CITY OF PATASKALA PLANNING & ZONING COMMISSION

STAFF REPORT

Planned Manufacturing Application PM-20-001

The Applicant is proposing to split approximately 7.63-acres of the southern portion from the overall property in order to construct a new building to house "Michael Shank Racing", a race car manufacturing facility.

MICHAEL SHANK RACING ITE & ZONING COMPLIANCE PLA CITY OF PATASKALA, OH

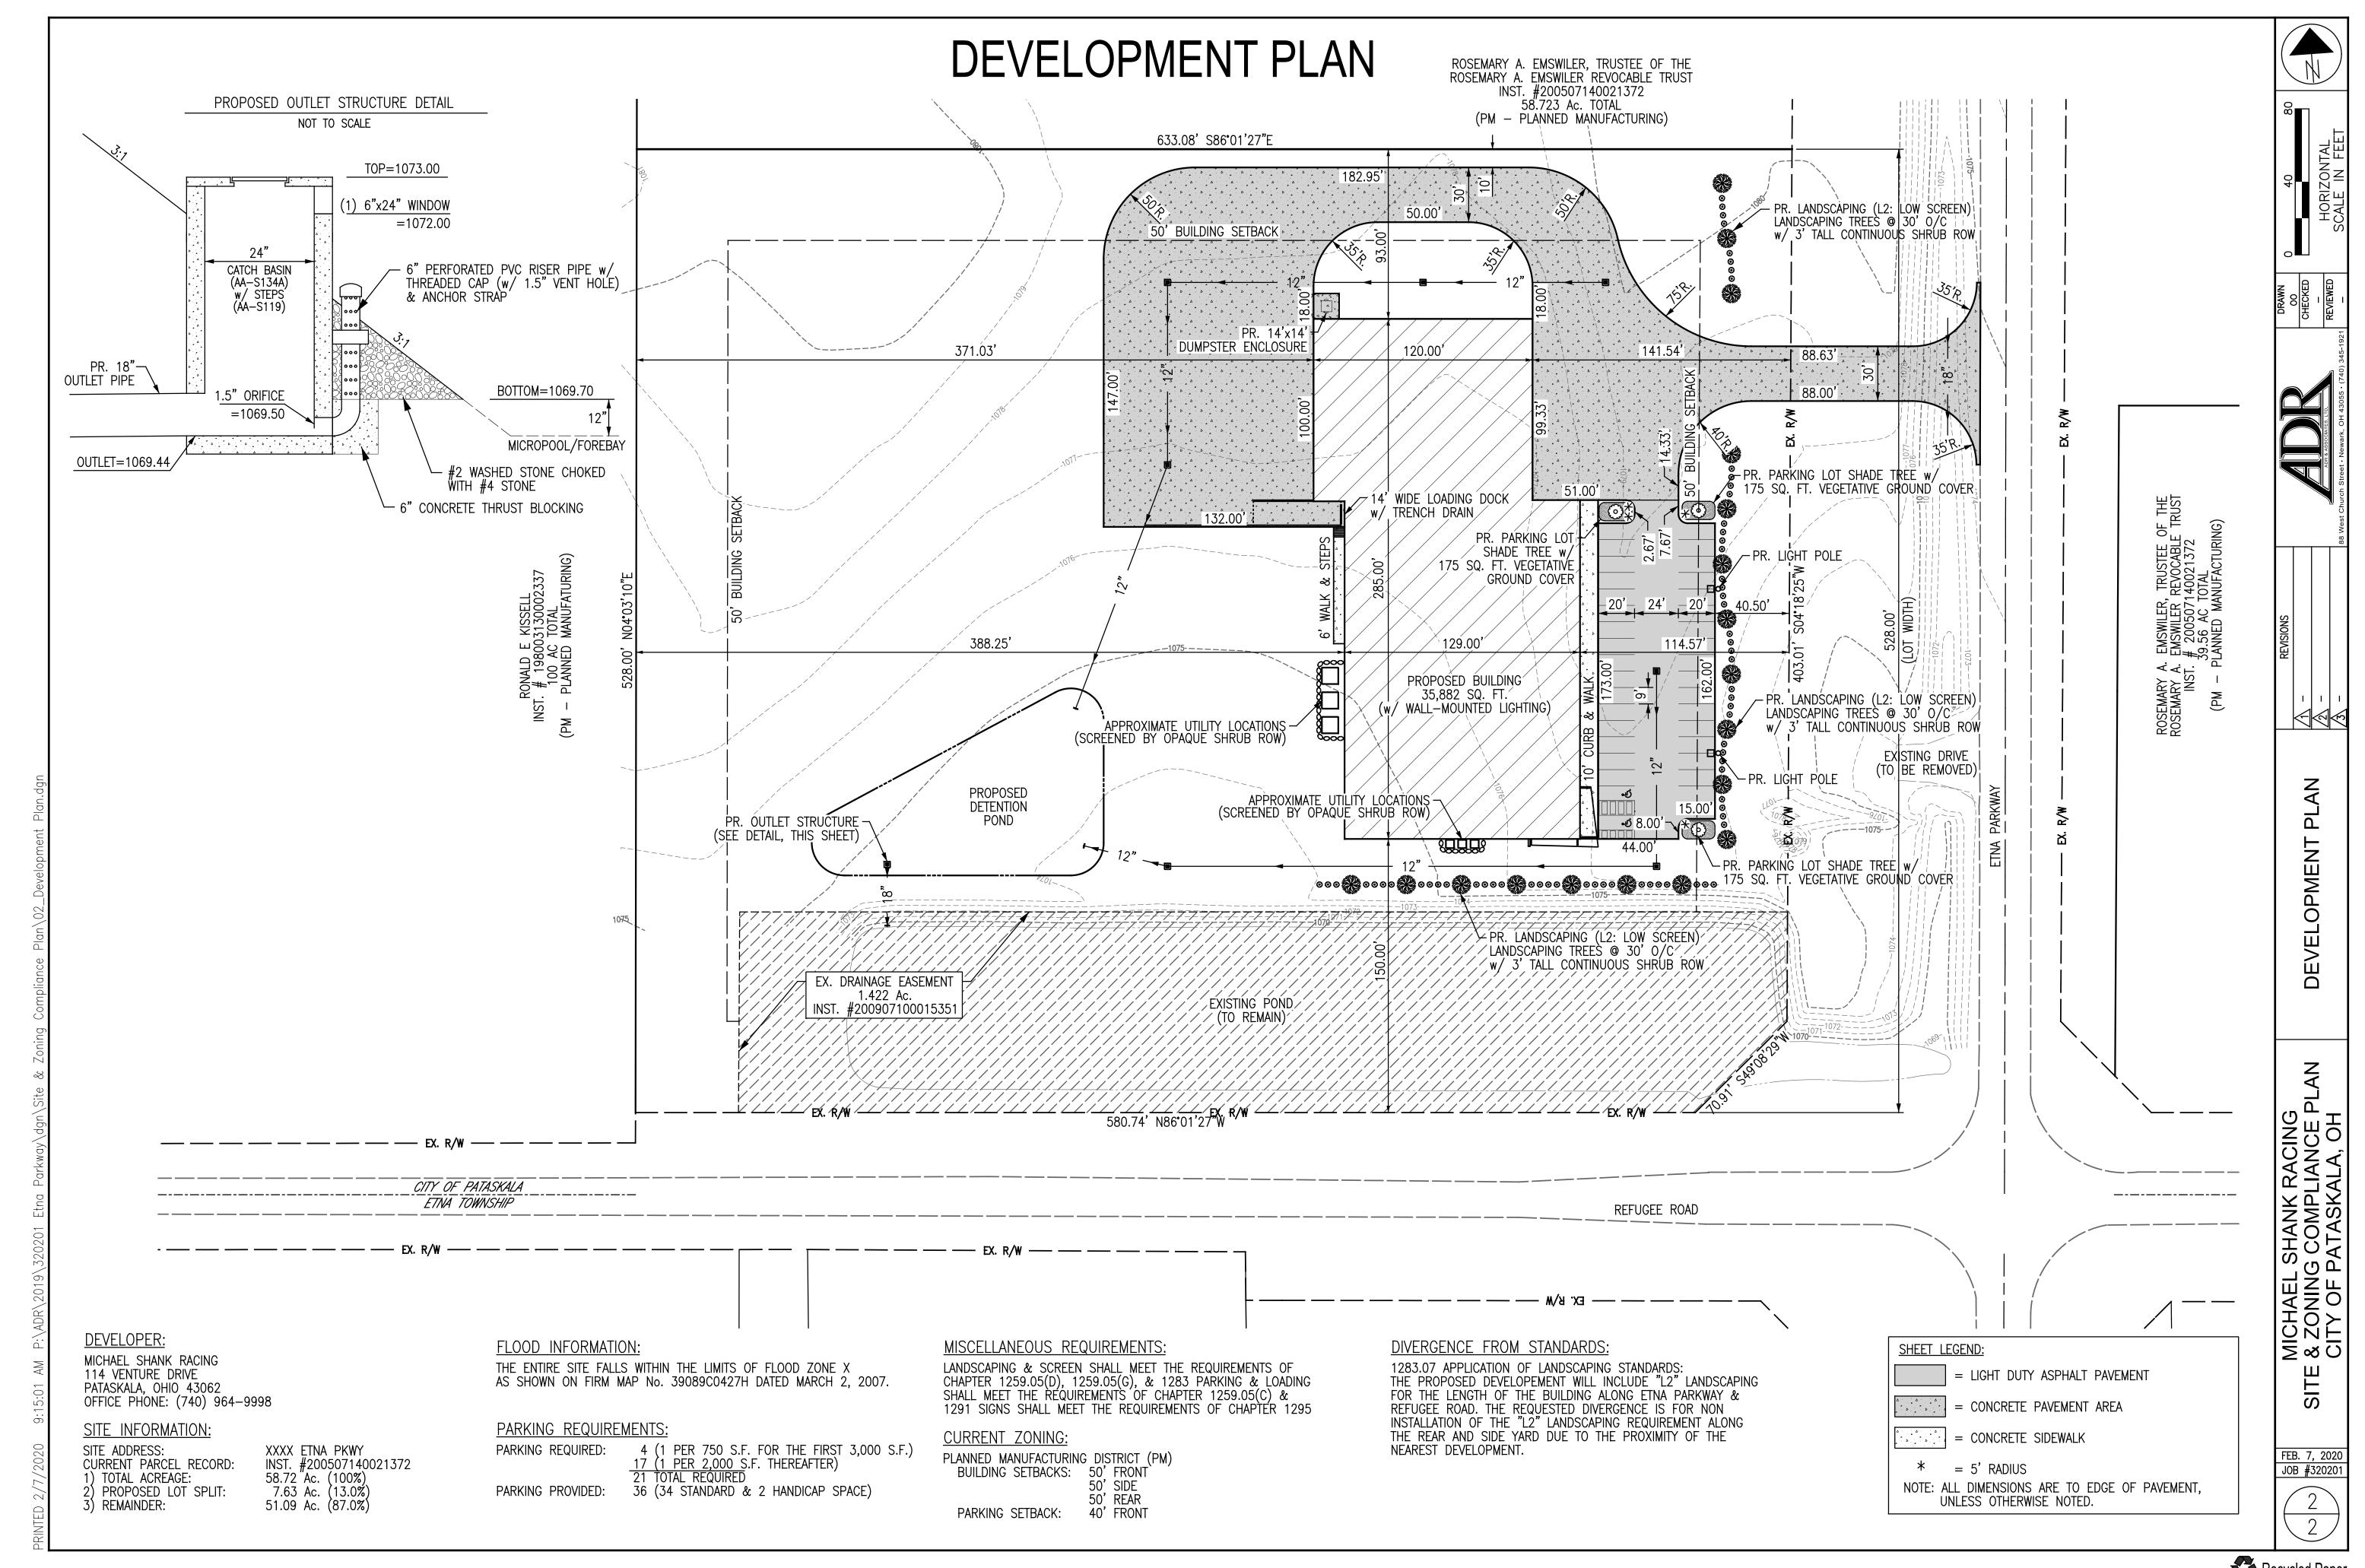
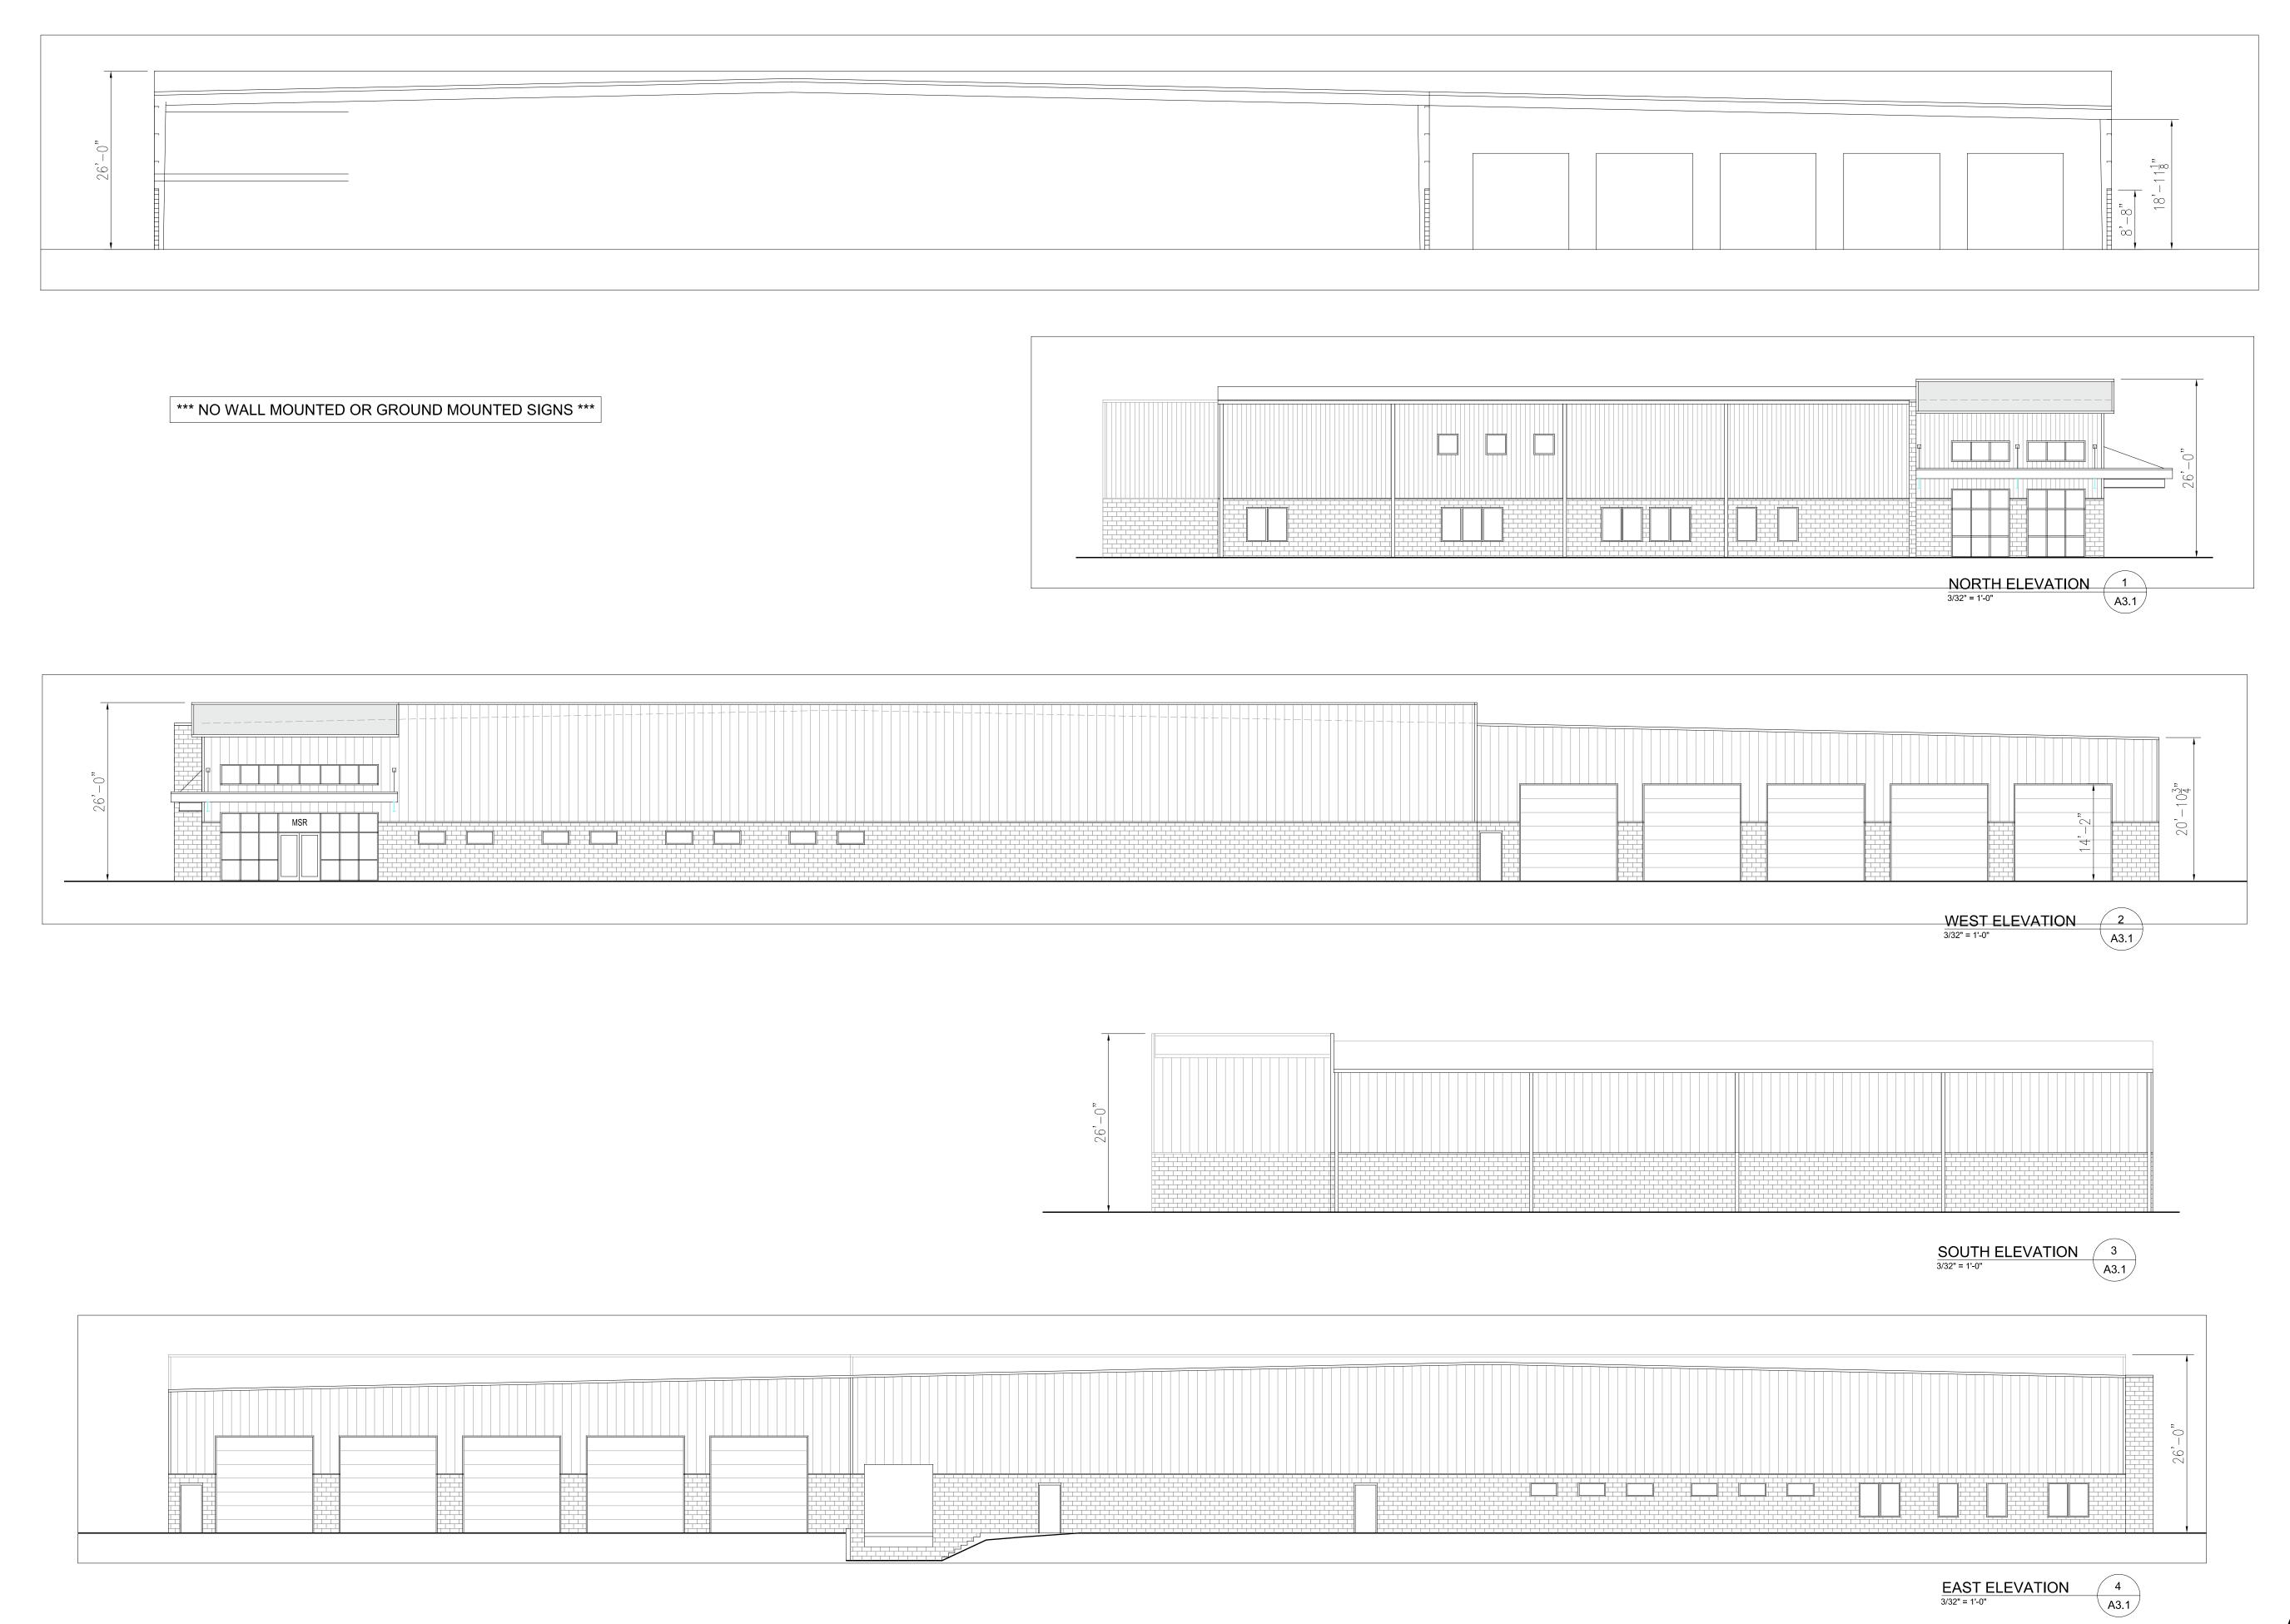
• Include a 'Site Statistics Table' showing the square footages/acres associated with the building, parking lot, detention pond, etc.

- On Page 2 of the Site Plan there is a section "Divergence from Standards" where it describes the requested variance from Section 1283.07(B). You are not requesting a "Divergence", change this to something referencing variances, not divergences.
- Also, on Page 2 under "Miscellaneous Requirements" references sections from Chapter 1259 Transportation Corridor Overlay District (TCOD). As this is not a TCOD, remove mentions of Chapter 1259.

- 1253.05(D): The maximum percentage of the total lot area which may be occupied by both principal and accessory structures shall be 65%.
 - With acreage of 7.63, and proposed structure size of 35,882-square feet the lot coverage would be approximately 11%. Indicate exact figures on plans.

- 1283.06(8)(d): Protection shall be provided for all landscaped areas from potential damage by adjacent development, parking, or storage area.
 - o Parking lot along east side shall have either a curb or wheel stops.

- Dumpster on northwest corner of building is within a proposed 14-foot by 14-foot enclosure.
 What is the height of the screening?
- 1283.06(15): Mechanical equipment located on the ground in industrial zoning districts shall be screened from the street or any abutting zones by walls, fences, or vegetation tall enough to screen the equipment.

- Opaque shrub screen proposed around utility locations, what is the height of the proposed screening?

- Width of handicap space not identified; length is compliant at 20-feet. Width of access aisle not identified. Details of slope -or- entrance ramp not included.

- Appears Applicant has gone with 1291.13(B)(1)(a) which requires interior landscaping at a rate of 20-square feet per stall and at least one (1) tree per 200-square feet of landscaped area. However, that would require 720-square feet of landscape area and 4 trees. Applicant is proposing 525-square feet and 3 trees. May need to increase with an additional tree island. Also, are these islands curbed?
